BOSTON EDISON

April 1, 1991
BECO Ltr. 91.044

BOSTON EDISON'S REVIEW OF THE TRANSCRIPT OF THE FEBRUARY 25, 1991
PUBLIC MEETING BETWEEN BOSTON EDISON AND THE NRC TASK FORCE
ON OFFSITE EMERGENCY PLANNING FOR PILGRIM

BOSTON EDISON'S REVIEW OF THE TRANSCRIPT OF THE
FEBRUARY 25, 1991 PUBLIC MEETING BETWEEN
BOSTON EDISON AND THE NRC TASK FORCE

EOP-03 PRIMARY CONTAINMENT CONTROL

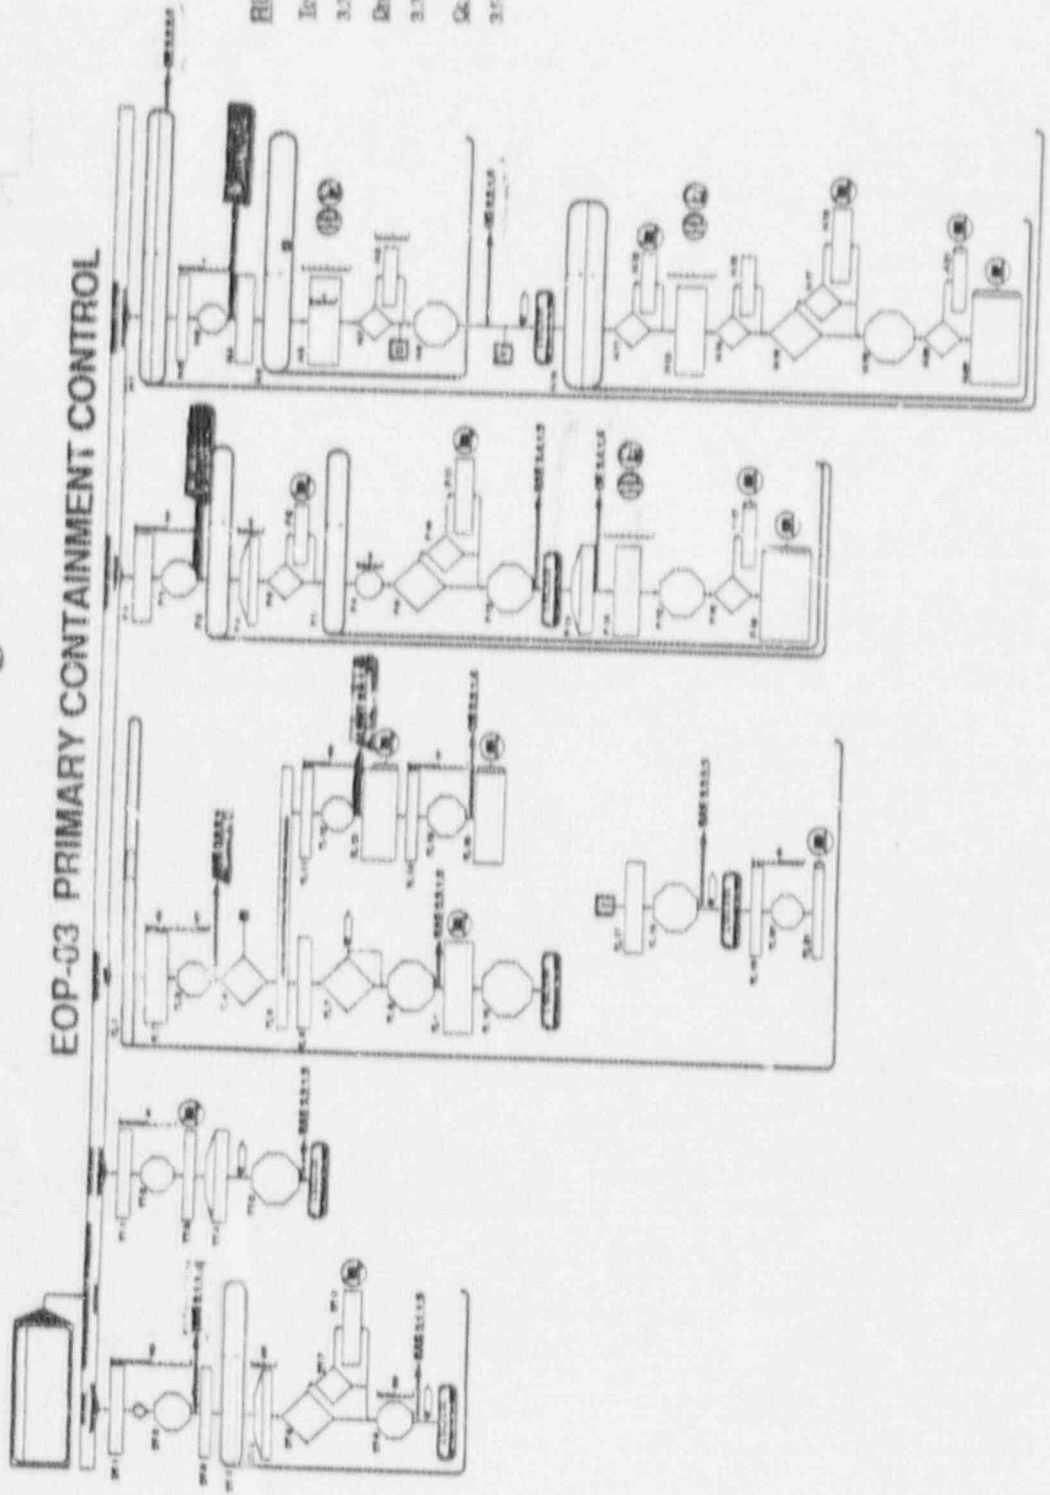
Mr. Mohseni requested a copy of the operator aide document used by the watch engineer when considering use of the direct torus vent.

A copy of the relevant pages from the Draft EOP-EAL Operator Aide pertaining to use of the direct torus vent, only after a General Emergency has been declared, is attached as Attachment 3. This Operator Aide document is presently under internal review. For additional information on this subject, see Boston Edison Response to item G below.
